Access Compliance Report

Public Rights-of-Way

Intersection ID: 10027413	Main Street: GOLF_LINKS_DR_N	Cross Street: N/A	Location: SW
ADA ID: 3B6AF40319FE	Ramp Type: PerpDiag	Initial Pass/Fail: Fail	Overall Compliance: No
		Severity Score: 12.5

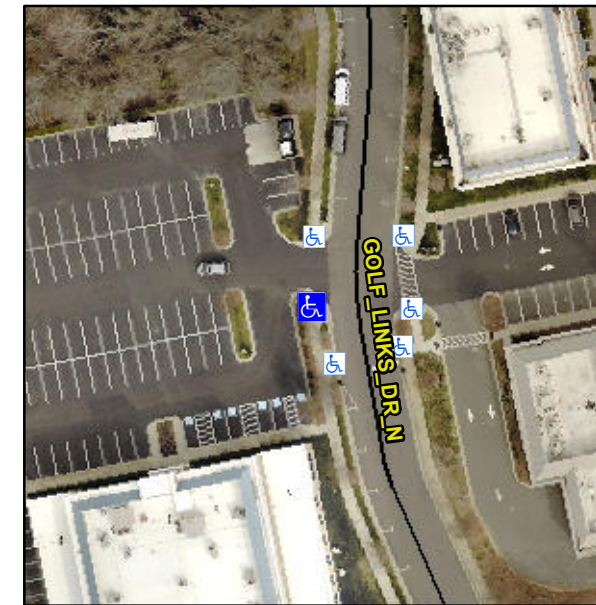
Not Found, R304.2.2

Compliance	Description	Data	Compliance	Description	Data
N/A	Ramp Length (in)	60.0	No	Ramp Slope (%)	9.2
Yes	Ramp Width (in)	48.0	Yes	Ramp XSlope (%)	1.6
N/A	Flare Type LT	N/A	N/A	Flare Type RT	N/A
N/A	Flare Slope LT (%)	N/A	N/A	Flare Slope RT (%)	N/A
N/A	Flare Traversable LT?	N/A	N/A	Flare Traversable RT?	N/A
N/A	Landing Length (in)	N/A	N/A	DWS Provided?	N/A
N/A	Landing Width (in)	N/A	N/A	DWS Contrast?	N/A
N/A	Landing Slope (%)	N/A	N/A	DWS Length (in)	N/A
N/A	Landing X Slope (%)	N/A	N/A	DWS Full Width?	N/A
N/A	Landing Curb? (Y/N)	N/A	N/A	DWS Offset (in)	N/A
N/A	Shared Landing?	N/A			
N/A	Gutter Ponding?	N/A	N/A	Gutter Slope (%)	N/A
N/A	Gutter Lip Ht (in)	N/A	N/A	Gutter X Slope (%)	N/A
N/A	Painted X Walk1?	No	N/A	Painted X Walk2?	No
	X Walk 1 Direction	To E		X Walk 2 Direction	To N
N/A	X Walk 1 Width (in)	N/A	N/A	X Walk 2 Width (in)	N/A
	X Walk 1 Slope (%)	7.2		X Walk 2 Slope (%)	0.7
	X Walk 1 X Slope (%)	2.6		X Walk 2 X Slope (%)	5.7

Remove & Replace Curb Ramp With Two New Directional Ramps or Equivalent.
